Development Services

Date: 07-14-2025**16:45:24****Final Report - Corrections Required**
Application No. PL8719**Comment Author Contact Information:**

PLAT OF KING'S LANDING UNIT 11

DATE PLOTTED: 06/19/25
COMP. NO.: PLAT-SH1
JOB NO.: 24008
SCALE: 1" = 60'
PLOT SCALE: SAME
SHEET 1 OF 3

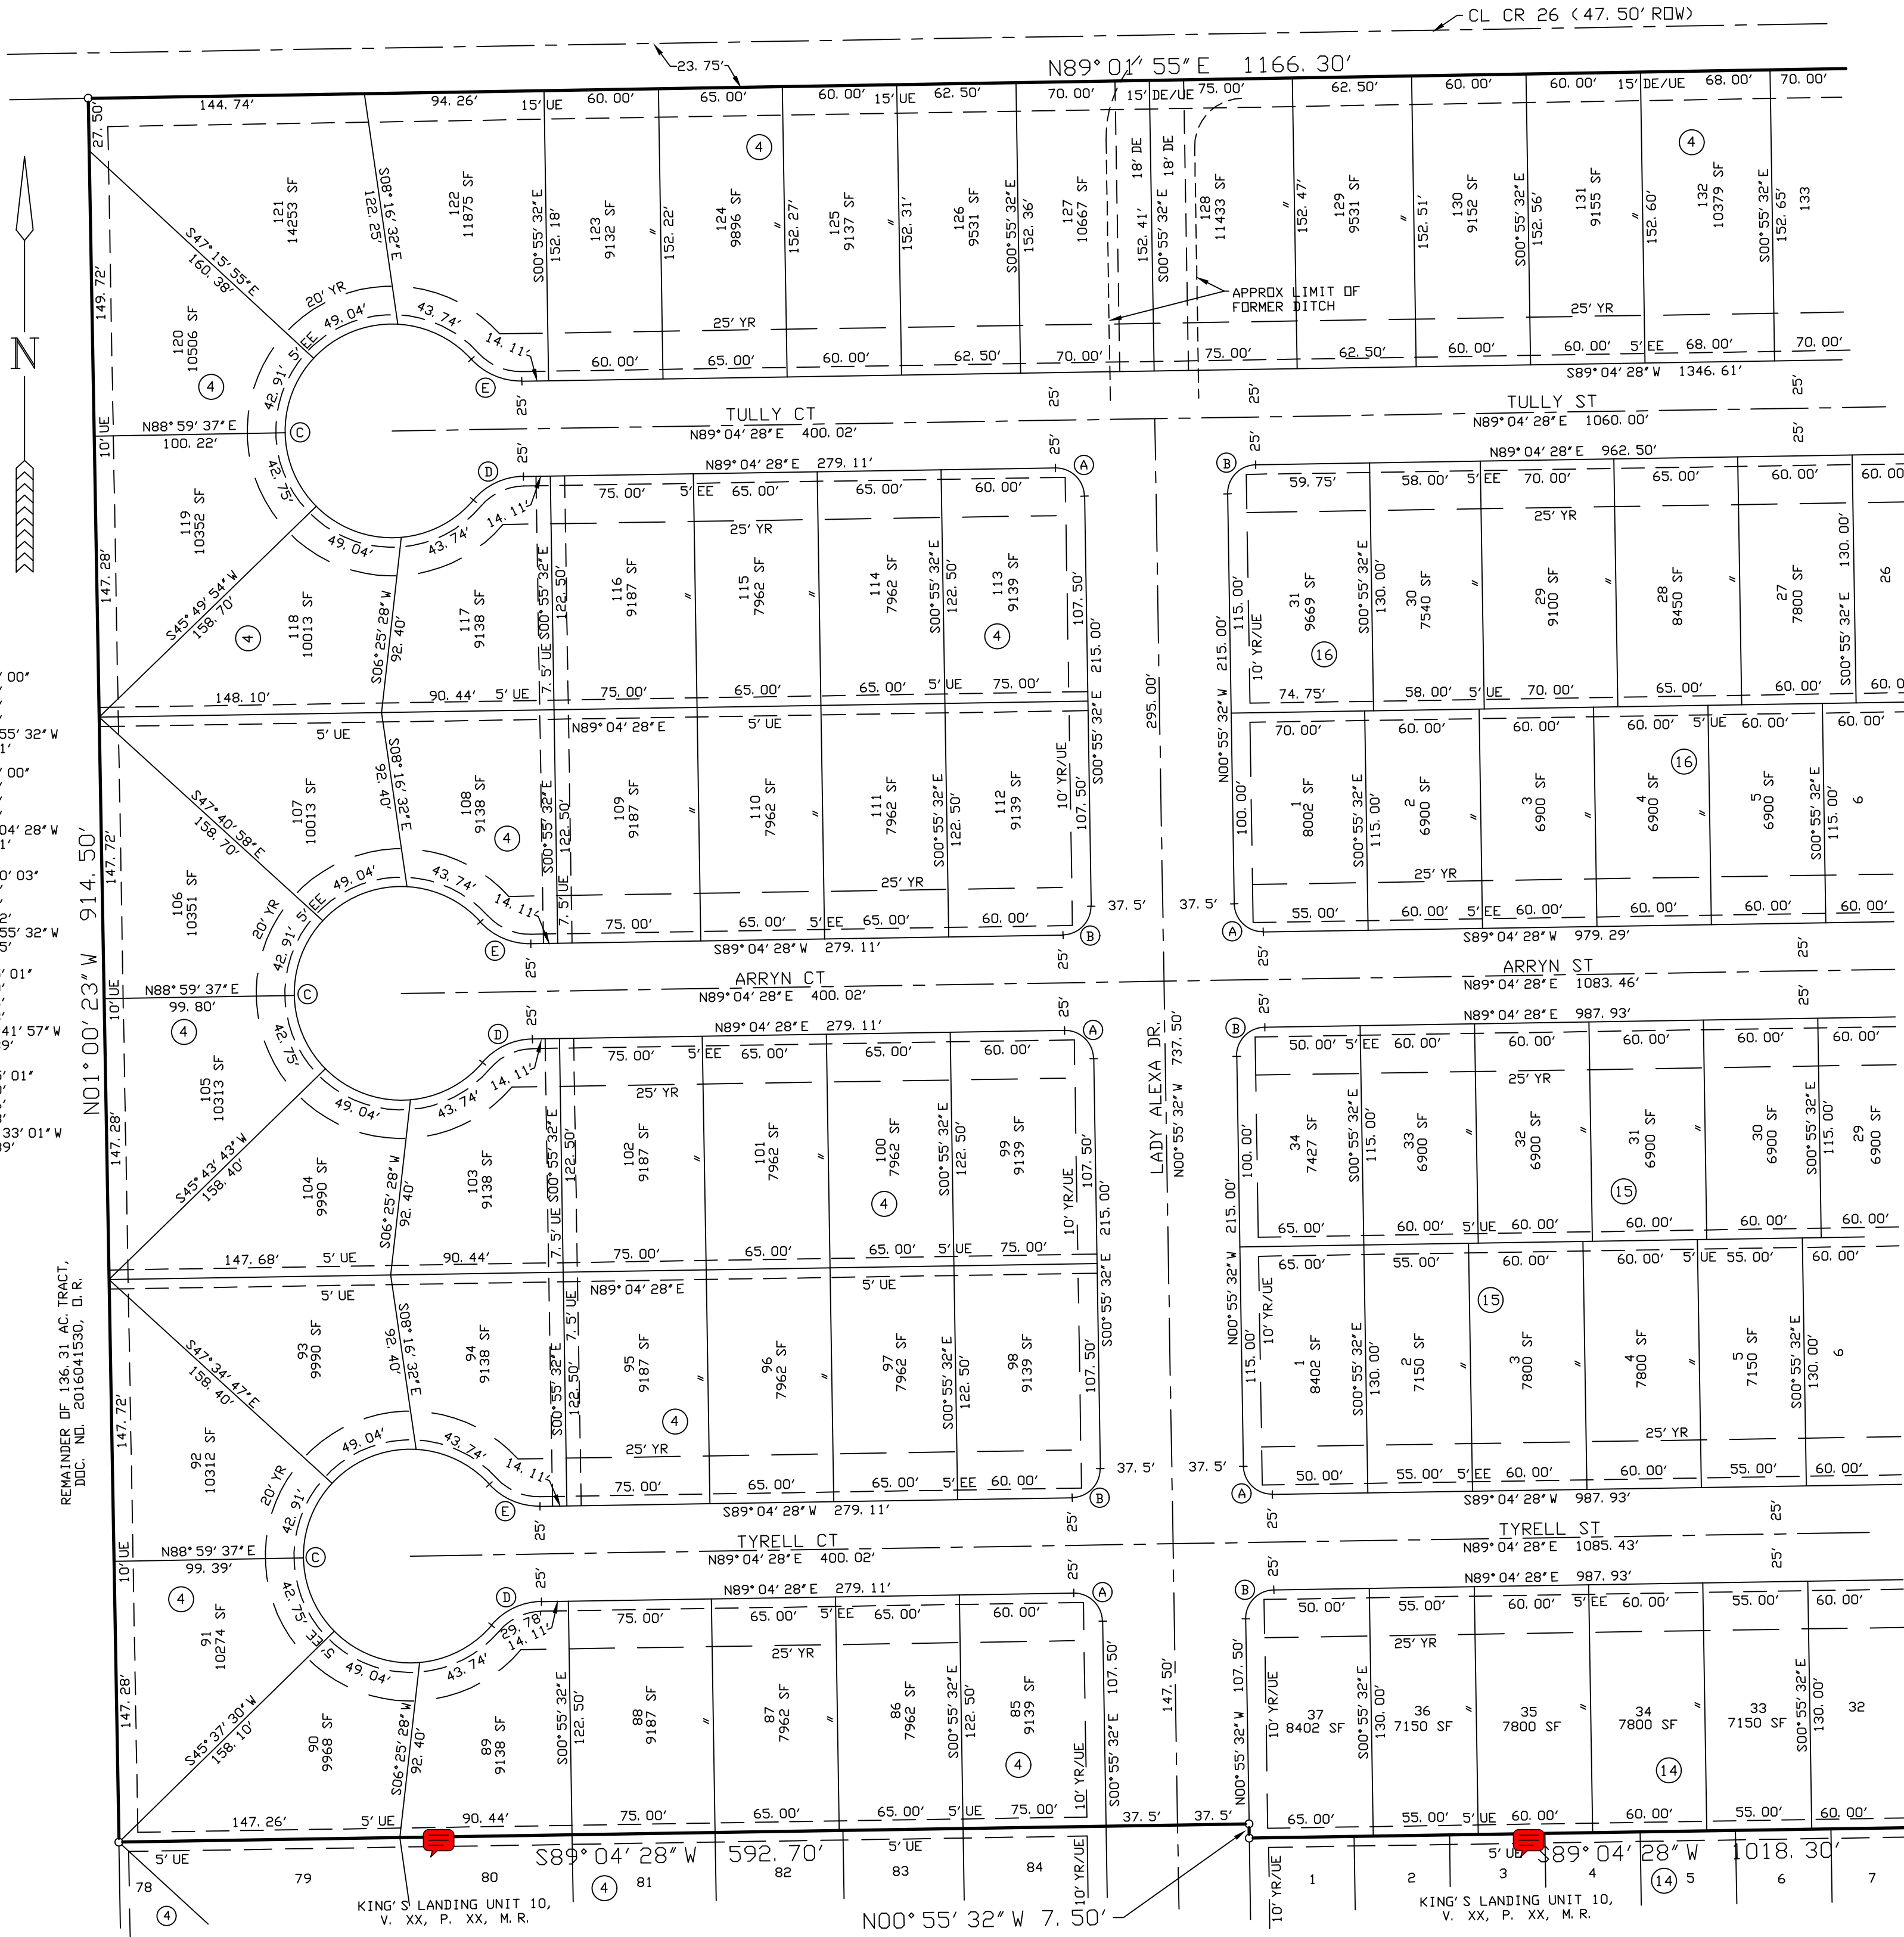
Comment ID	Page Reference	Annotation Type	Author : Department	Status	Review Comments
1	P001	Note	Elena Buentello : DS	Open	UDC 3.1.6.B.2.A Please submit an application and all other required documents for this application.
2	P001	Note	Mark Zans : DS	Closed	The submitted application has been accepted. We are now in need of the following: 1. A signed copy of the DOI form. 2 A copy of the deeds for the land showing correct ownership for MPM Development. 3. A utility plan showing all utility connections. 4. A SWQMP for the site and show calculations. The plat cannot move forward unless all required plans and documentsd are submitted.
30	P001	Note	Alex Harmon : DS	Open	6/25/25 UPDATE: To be addressed with Pls. Plat may need to be adjusted based on review. Please review IDM Ch. 3.05: No Adverse Impacts. For new developments and other improvements that will increase the impervious cover, decrease the time of concentration (Tc), or increase peak flows from drainage areas, mitigation of adverse storm water impacts shall be required. Mitigation methods shall be designed to release the post-development storm water runoff from a site at a controlled rate, which does not exceed the predeveloped peak runoff rate. Habitable structures must be mitigated to the 100 yr-storm event, per UDC 8.2.8

31	P001	Note	Alex Harmon : DS	Open	6/25/25 UPDATE: Separate SWQMP should be submitted that shows path of delineation as well as pre and post flows. See Plat Submittal application checklist for more information. Per City of Corpus Christi - Code of Ordinances Ch. 14, Art.X, Sec. 14-1003, a Storm Water Quality Management Plan (SWQMP) is required. The following information is not included with the submittal: -Hydraulic calculations based upon established procedures (such as the rational method). This should be done for the predeveloped land and post developed land.
32	P003	Note	Alex Harmon : DS	Open	6/25/25 UPDATE: Contact USACE as they are the only ones who can determine if this is actually wetlands. The US Fish and Wildlife Service (FWS) identifies one wetland areas within this proposed platted area. please identify the area on this plat. Approval from the USACE is needed prior to recordation/construction in these areas.

14	P001	Note	Mark Zans : LD	Closed	Provide state surveyor registration number.
20	P001	Note	Mark Zans : LD	Closed	Plat is a final plat.
21	P001	Note	Mark Zans : LD	Closed	This plat is on the 30-day tract for approval, approval with Conditions, or disapproval by 6/25/2025. The deadline for revisions to be submitted is 6/19/2025
22	P001	Note	Mark Zans : LD	Closed	The plat will be recommended as Conditional Approval for Resolution comments received and that have remained Open and unmet.
23	P001	Note	Mark Zans : LD	Closed	A request or response may be made for an additional 30 days for Public Notice plat with a Waiver or to res olve Open comments. This request must be made directly to Development Services within the 30-day initial period.
27	P001	Note	Mark Zans : LD	Closed	fire comments 1-10 1 Infor.□Water Distribution Standards: Fire flow for residential areas require 750 GPM with 20 psi residual 2□Plat□The UDP has a standard regarding the continuation of streets. Will Natasha Lane be

36	P001	Note	Mark Zans : LD	Closed	<p>PW Streets comments:</p> <ul style="list-style-type: none"> •PW STR: Were our PIP comments for this unit addressed? If so, can we see the developer's answers? •PW STR: Please provide an overall location map that identifies all units within King's Landing •PW STR: Informational - RCC pavement section shall adhere to Section 2 of the Pilot Program for Roller Compacted Concrete Roadway Improvements and Participation Agreement for Kings Landing Subdivision •PW STR: Informational - County Road 26 is on the Transportation Plan as a C3 Collector. Please coordinate with Public Works Traffic Department for a proposal to modify the Urban Transportation Plan.
